PRODUCT SERVICE NOTICE

DATE: 2/17/81	VI	B 1	- 1
CLASSIFICATION VS SYSTEMS			
PRODUCT/ APPL DISK I/O PROCESSORS			
SEQUENCE # 1			
TITLE: MODEL 22V18 DISK IOP FOR VS-50 COMPUTERS	- -

The PROM loading for the 22V18 IOP is shown below. (PROM's are located on the WL# 210-7110-V IOP Motherboard.)

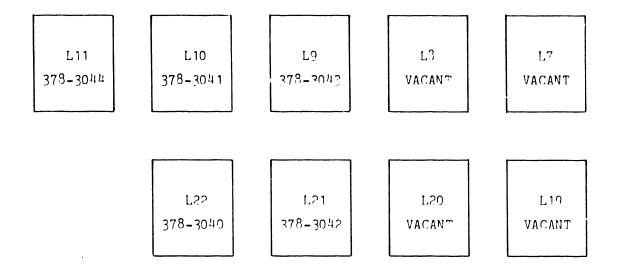
A new disk IOP, the 22V18 (WL# 177-7069 or WL# 212-3026), has been introduced specifically for use with the VS-50 Computer. The 22V18 hardware is identical to that of the 22V08 IOP (a WL# 209-7110 IOP Motherboard and a WL# 210-7114 Device Adapter); the 22V08 firmware (PROM's) was modified to create the 22V18 IOP. (This initial 22V18 microcode is version 4.02.00.) With the new PROM's loaded, the part number for the IOP motherboard is WL# 210-7110-V.
